### ADDENDUM No. 3

REQUEST FOR TENDER No.:	1220-020-2023-004
TITLE:	DISTRICT ENERGY TRANSFER STATIONS AND ASSOCIATED WORKS
ADDENDUM ISSUE DATE:	SEPTEMBER 1, 2023
CLOSING DATE AND TIME:	ON OR BEFORE THE FOLLOWING DATE AND TIME (THE "CLOSING TIME"): TIME: 11:00 A.M. (LOCAL TIME) DATE: SEPTEMBER 7, 2023

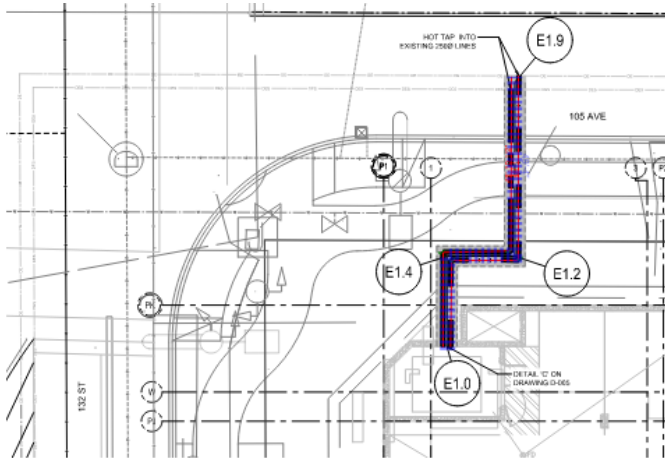
**Q.2.** What is the depth of cover on pipes at the location below as there are no profiles? [Refer to Attachment 2]

**A.2.** The Quinn buried piping's elevation is intended to be field matched with the interior piping in the level P1 DEU Room and should align with the tie-in flanges (elevation currently unknown). It can be assumed for the tender that the depth of cover on pipes will be up to a maximum of 2m.

# Attachment 1

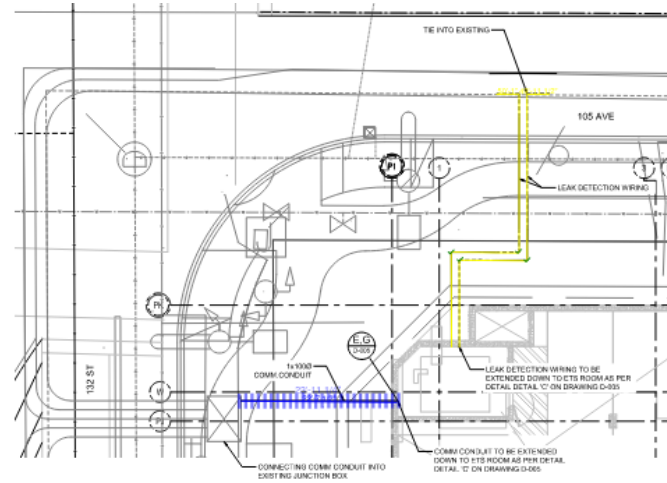
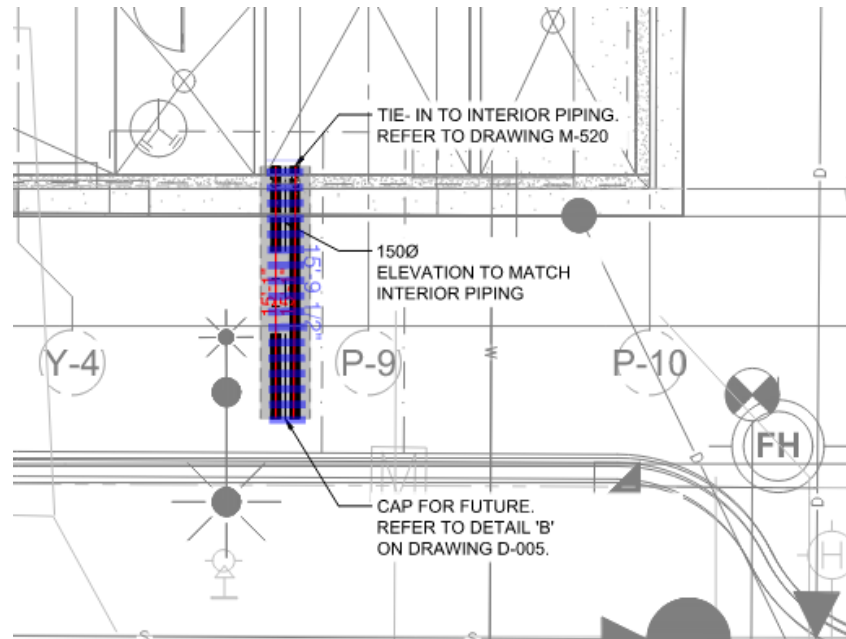
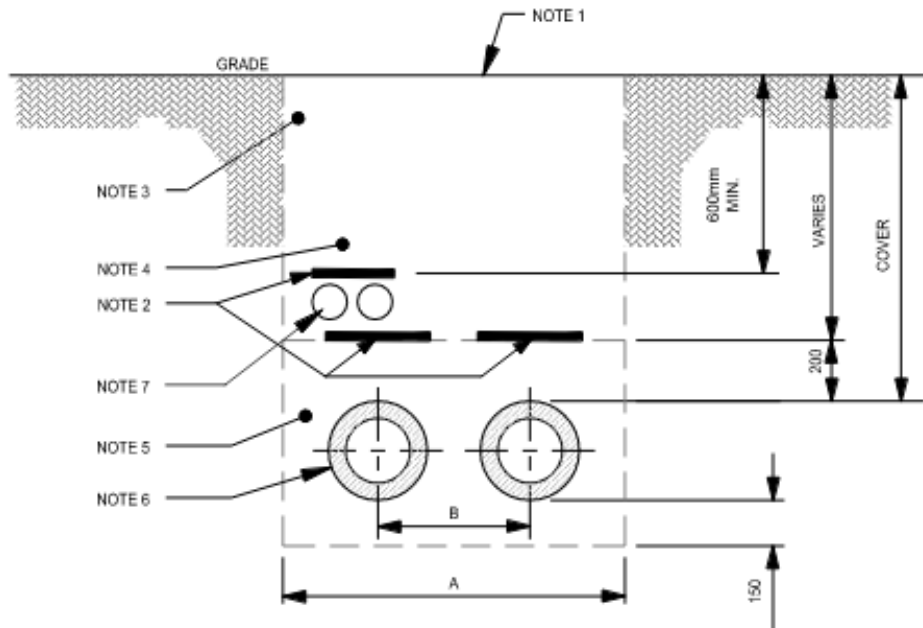
**Q.1.** Please advise on the backfill to be utilized. Please confirm that note 4 & 5 are across all the locations shown [Refer to Attachment 1].

**A.1.** Note 4 refers to Type 1 / 2 fill under roadways and approved Type 3 fill under boulevards / non-roadway surfaces. Note 5 refers to Type 4 fill. Refer to the following information:

Type 1 Fill (Granular 'A' Base Material) and Type 2 Fill (Granular 'B' Sub-base Material):

1. Crushed, screened stone, gravel or sand consisting of hard durable particles free from clay lumps, cementation, organic material and other deleterious materials. Pit run granular material will not be considered as acceptable.

2. Gradations to be within limits specified when tested to ASTM C136 and ASTM C117, as shown in Table 2. Sieve sizes to CAN/CGSB 8.1.

Type 3 Fill: selected backfill material from excavation or other sources, approved by Consultant for use intended, unfrozen and free from rocks larger than 75 mm, cinders, ashes, sods, refuse, ice, vegetable matter or other deleterious materials.

Type 4 Fill (Sand bedding):

1. Sand Consisting of hard durable particles free from lumps, cementation, organic material, and other deleterious material.
2. Gradations to be within limits specified in Table 3.
